SERVICE - INFO

LuK Nr: 128 0055 11 – 280mm DBVR

Bulletin 988 2000 960

CASE IH, MANITOU, VOLVO**

**Flywheel
Schwungrad
Volant-moteur
Volante-motor
Volano**

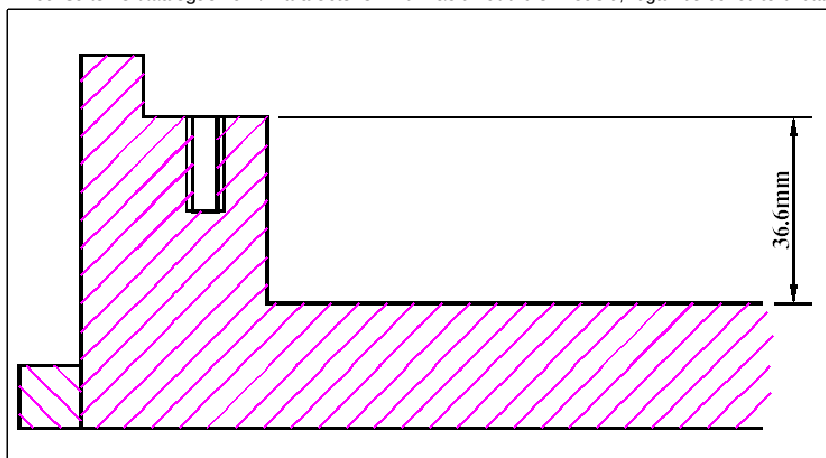
Info:	128 0055 11 replaces / ersetzt / remplace / sustituye a / sostituisce 128 0055 40 + 128 0055 41
(GB)	Please ensure that the flywheel is machined to a pot depth of 36.6mm.

Info:	Fig 2 replaces / ersetzt / remplace / sustituye a / sostituisce Fig 1
-------	---

Fig 3

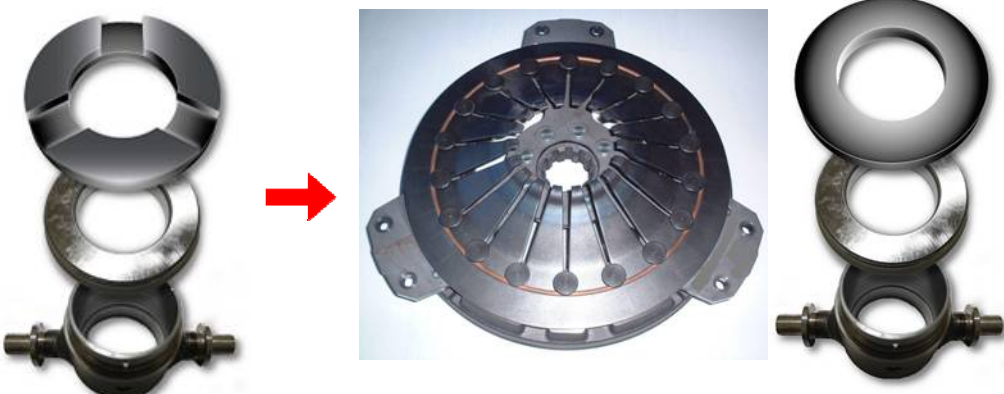
Info:	Fig 4 replaces / ersetzt / remplace / sustituye a / sostituisce Fig 3
-------	---
